Project	<b>IEEE 802.16 Broadband Wireless Access Working Group</b> < <a href="http://ieee802.org/16">http://ieee802.org/16</a> >	
Title	<b>Preamble design to enhance MIMO support</b>	
Date Submitted	<b>2004-06-25</b>	
Source:	Wen Tong, Peiying Zhu, Jianglei Ma, Ming Jia, Hang Zhang and Mo-Han Fong Nortel Networks 3500 Carling Avenue Ottawa, ON. K2H 8E9 CANADA	Voice: (613)-763-1315 Fax: (613)-765-7723  <a href="mailto:wentong@nortelnetworks.com">wentong@nortelnetworks.com</a>
Re:	IEEE 802.16e D3 Draft	
Abstract	Preamble design to improve MIMO support	
Purpose	To incorporate the changes here proposed into the 802.16e D4 draft.	
Notice	This document has been prepared to assist IEEE 802.16. It is offered as a basis for discussion and is not binding on the contributing individual(s) or organization(s). The material in this document is subject to change in form and content after further study. The contributor(s) reserve(s) the right to add, amend or withdraw material contained herein.

# Preamble design to improve MIMO support

Figure 1 MIMO permeable time domain structure

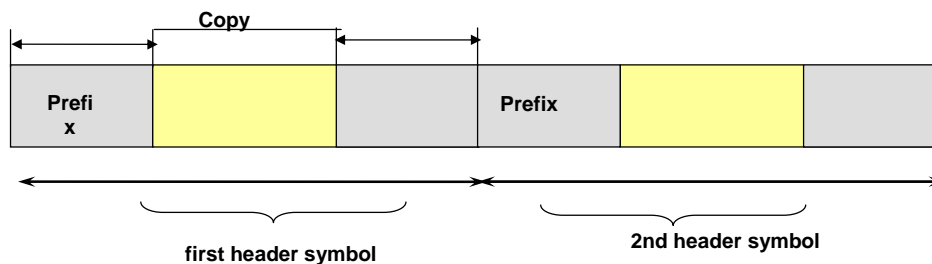
[Add the following text into section 8.4.9.4.3.2]

In this section, we describe the principle using 1k FFT as an example. The preamble is transmitted at the beginning of the DL transmission in each frame. It consists of two header OFDM symbols. The time domain structure of the preamble is as below:

The first header OFDM symbol serves as the common SYNC channel, a common PN sequence consisting of two sub-sequences is used by all cells to modulate the subcarriers with even-numbered frequency offset Indices.

- For single antenna, the whole sequence is transmitted by one antenna.
- For 2 or 4 antennas, antenna 1 modulates sub-carriers with frequency offset indices of  $4m$  ( $m=0,1,2,\dots,N_{\text{carrier}}/4-1$ ) with sub-sequence 1, antenna 2 modulates sub-carriers with frequency offset indices of  $4m+2$  with sub-sequence 2.

The second half of the time domain waveform is a replica of the first half one, frame sync and coarse timing can be extracted based on this repetition structure.
